BID ADDENDUM # 2
TROUT VALLEY NATURE PARK

DATE ISSUED – September 22, 2026

TROUT VALLEY NATURE PARK

TROUT VALLEY NATURE PARK
VILLAGE OF TROUT VALLEY
TROUT VALLEY, ILLINOIS

SHEET NO.
G002

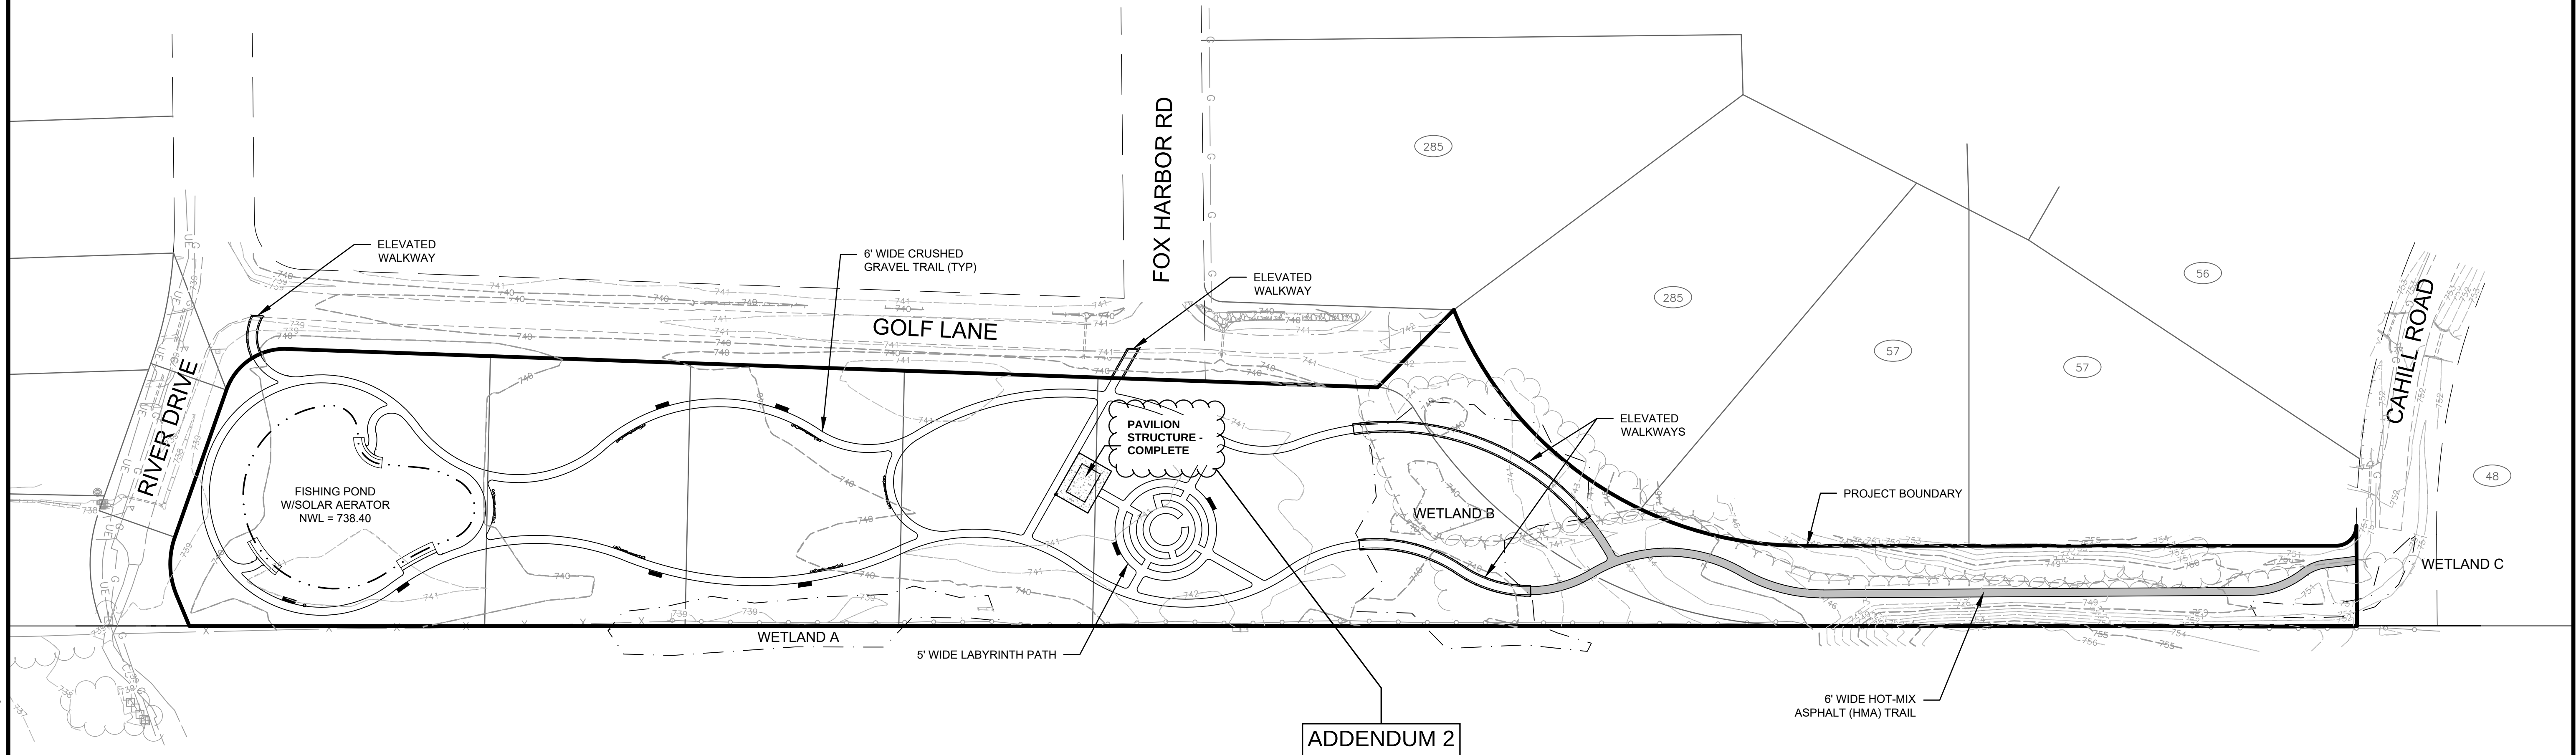
Sheet G001 is amended to reflect the revisions. G002 is amended to reflect corrections in the Summary of Quantities. Sheet G004, C111, are amended to reflect a corrected pay item callout for Pavilion Structure-Complete. Sheet C107-C109 are amended to correct the legend to show tree stump removal. Sheet L102-L104 are amended to correct the legend to clarify the Pavilion Structure Complete Detail location. Sheet L504

3 BENCH

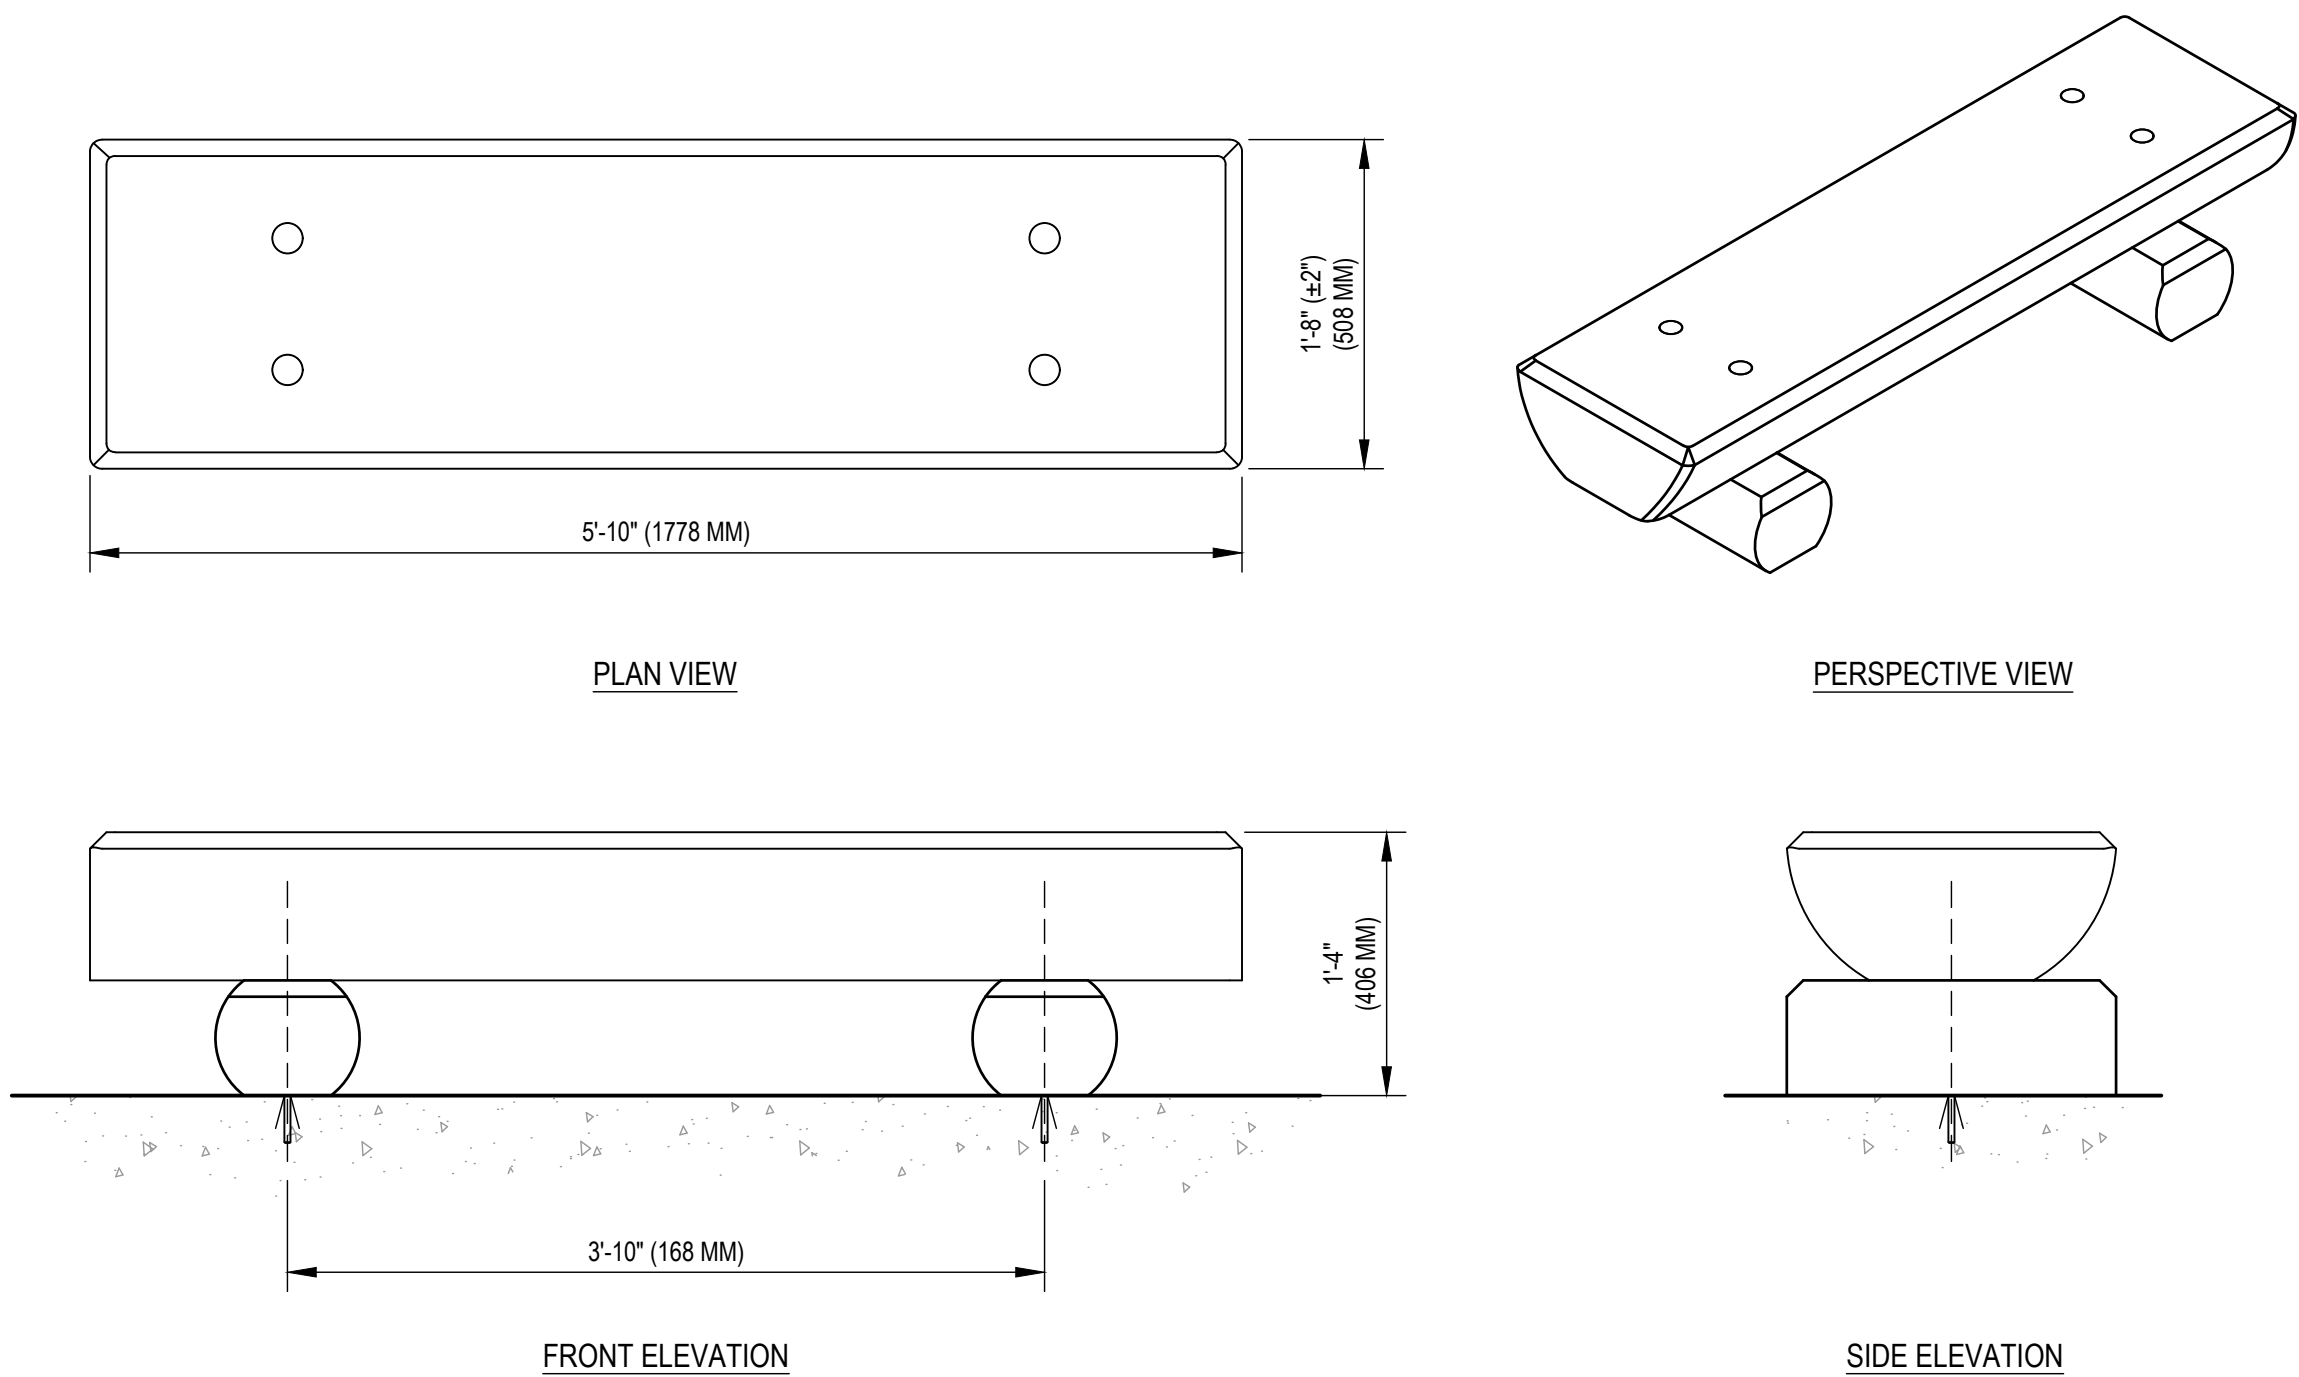
is amended to include submittal requirements on manufacturer information for Bench, Trash Receptacle, Dog Waste Station, and Fishing Line Recycling Bin.

CONTRACTOR TO SUBMIT MANUFACTURER INFORMATION FOR OWNER APPROVAL, PRIOR TO INSTALLATION
